# UNITED STATES PATENT AND TRADEMARK OFFICE

APPLICATION NO.	FILING DATE	FIRST NAMED INVENTOR	ATTORNEY DOCKET NO.	CONFIRMATION NO.
09/981,165	10/17/2001	Steve Dispensa	1585	7084
28004	7590	01/20/2006	EXAMINER	
SPRINT 6391 SPRINT PARKWAY KSOPHT0101-Z2100 OVERLAND PARK, KS 66251-2100				PATEL, ASHOKKUMAR B
ART UNIT		PAPER NUMBER		
2154

<b>Advisory Action Before the Filing of an Appeal Brief</b>	<b>Application No.</b>	<b>Applicant(s)</b>
	09/981,165	DISPENSA ET AL.
	<b>Examiner</b>	<b>Art Unit</b>
	Ashok B. Patel	2154

FIG. 2

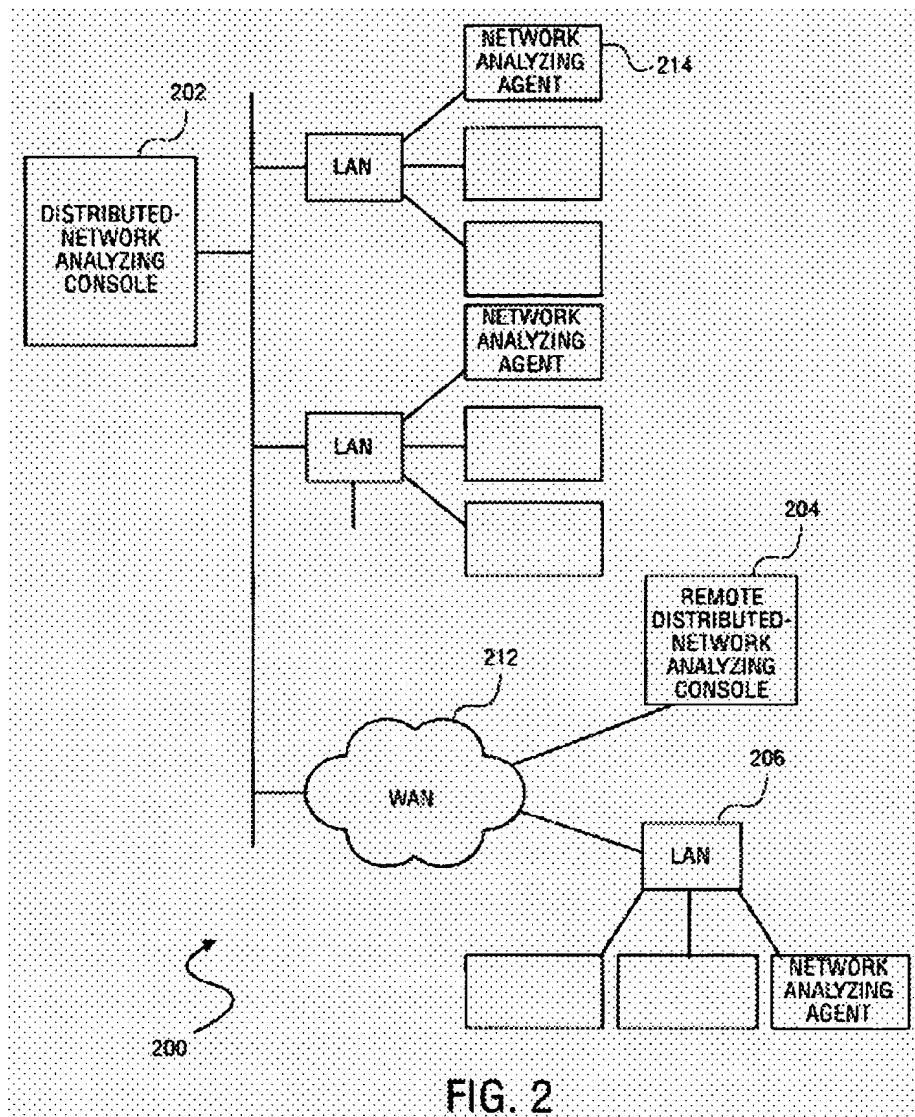
“However, neither the distributed-network analyzing console 202, nor any other apparatus disclosed in Hansen performs the method for operating a performance management system as set forth in claim 1.”

“Hansen does not mention a separate performance management system communicating with each of the analyzing consoles 202, 204, the network analyzing agents 214, and the MIB 420.”

As depicted in Fig. 2 and explained below the “distributed-network analyzing console 202” is a separate performance management system communicating with each of the analyzing consoles 204.

Hansen indicates in col. 5, line 65 through col. 6, line 3, " Network interface 312 is used by network analyzing console 300 to communicate with the various agents on the network. Network analyzing console 300 may be either a local-network analyzing console 108, a distributed-network analyzing console 202, or remote distributed-network analyzing console 204."

Also, in col. 5, line 30-32, Hansen indicates "Distributed-network analyzing console 202 formats and displays the data in a format that can be easily manipulated and acted upon."

Thus, the "distributed-network analyzing console 202" is a separate performance management system communicating with each of the analyzing consoles 204. and the network depicted in Fig. 2 is an apparatus of Hansen sending instructions for RMON information to, and then receiving RMON information from, each of an RMON probe, an RMON manager configured to access the RMON probe. and an RMON database configured to be accessed by the RMON manager. as provided for in amended claims 1, 9 and 17."
